Mobile Intel[®] Pentium[®] II Processor Specification Update

Release Date: December 2006

Order Number: 243887-057

The Mobile Pentium[®] II processor may contain design defects or errors known as errata which may cause the product to deviate from published specifications. Current characterized errata are documented in this Specification Update.

Figure 2. Workaround Flowchart: SMBALERT#-Driven System

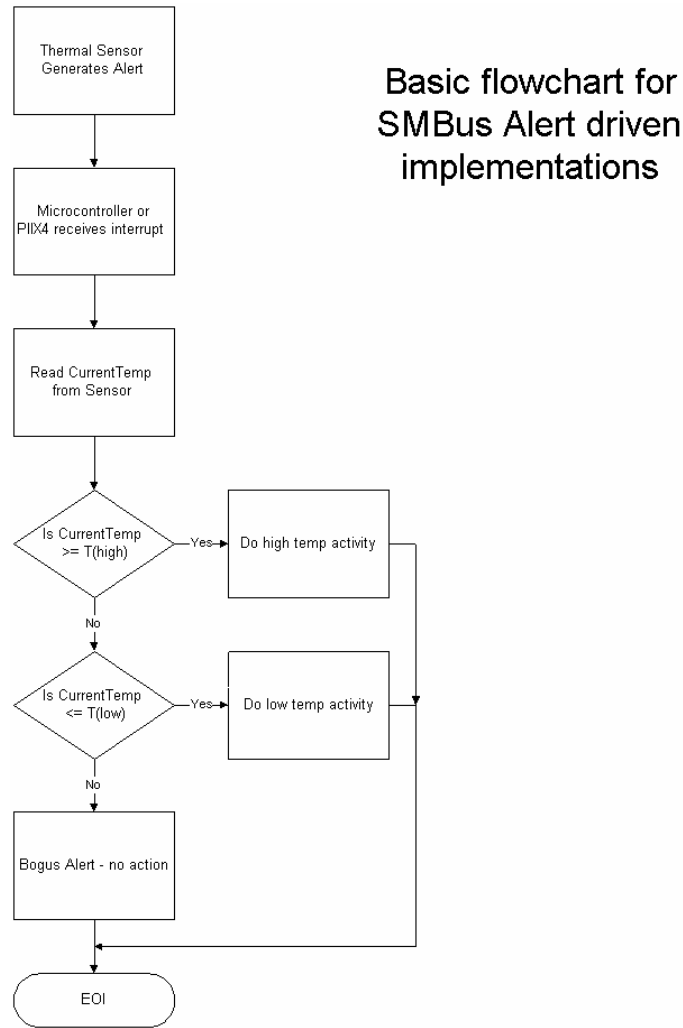
Problem: The Mobile Pentium II processor and the Pentium II Processor Mobile Module have a thermal sensor that monitors the processor core's temperature. Please note that desktop systems could have a similar thermal device. The thermal sensor asserts SMBALERT# if the processor temperature exceeds the temperature limits set in the Alarm Threshold Registers (T_{HIGH} , T_{LOW}). It also sets the corresponding Status Register bits to identify the cause of the interrupt. Figure 1 gives one example of the how the SMBALERT# signal could be used in a system.

Under the conditions described below, the thermal sensor incorrectly generates the SMBALERT# interrupt. All of the following conditions must be met to trigger a false interrupt:

1. Before servicing an interrupt from the thermal sensor, read and compare the processor thermal reading with the threshold limits (T_{HIGH} or T_{LOW}). Figures 2 and 3 provide basic flowcharts for the implementation of this workaround in an interrupt driven system.
2. If the firmware implemented polls the Status Register only, then before taking any action, re-read the temperature register and do a comparison with the alarm threshold limits (T_{HIGH} or T_{LOW}) to determine if the value is actually still within the temperature window.

- Use a temperature polling scheme to monitor the processor temperature.

Figure 1. TAP Gageable Thread Clarification

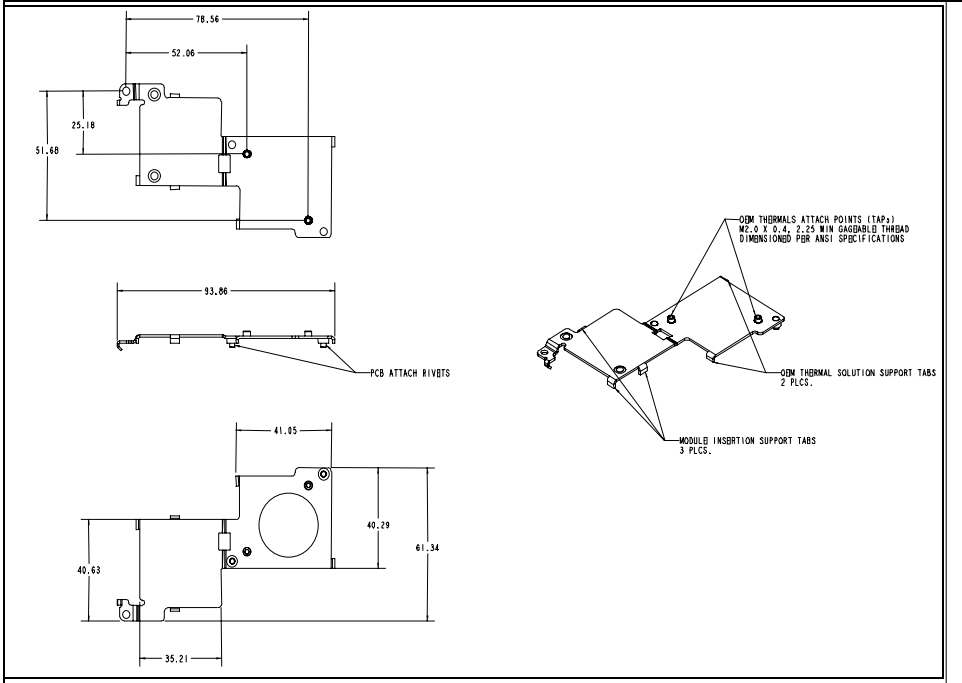
In the *Intel® Pentium® II Processor Mobile Module : Mobile Module Connector 1 (MMC-1)* and the *Intel® Pentium® II Processor Mobile Module : Mobile Module Connector 2 (MMC-2)* datasheets (Order Numbers 243667 and 243668, respectively), the thermal attach point (TAP) gageable thread specification was not clearly identified in Figure 14, of Section 5.2. The following is the TAP clarification:

OEM Thermal Attach Points (TAPs) M2.0 x 0.4, 2.25 min gageable thread dimensioned per ANSI specification.

See Figure 1 below for more information.
